Amendment to the Drawings:

"ANNOTATED SHEET SHOWING CHANGES"

Fig. 1

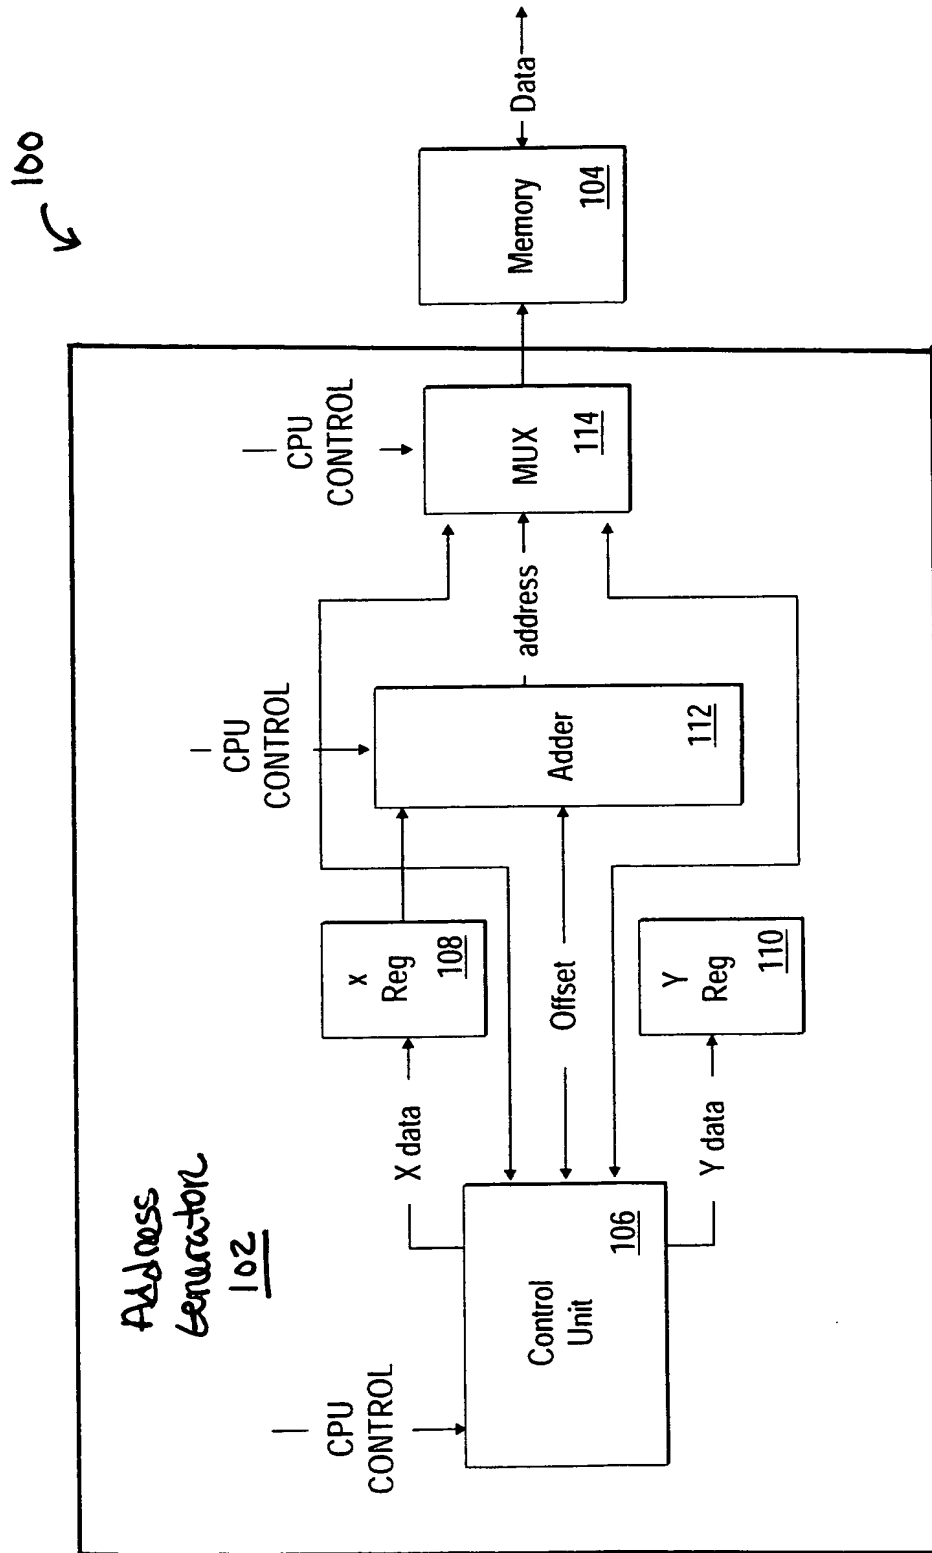
Applicant respectfully notes that figure 2 has been corrected to indicate "count_enable" for item 210 and "counting control logic" for item 204. Figure 3 has been corrected to indicate "Xstep" for item 314. Figure 1 has been amended to show "system 100" and "address generator 102."

Figure 1 has been amended to show "system 100" and "address generator 102."
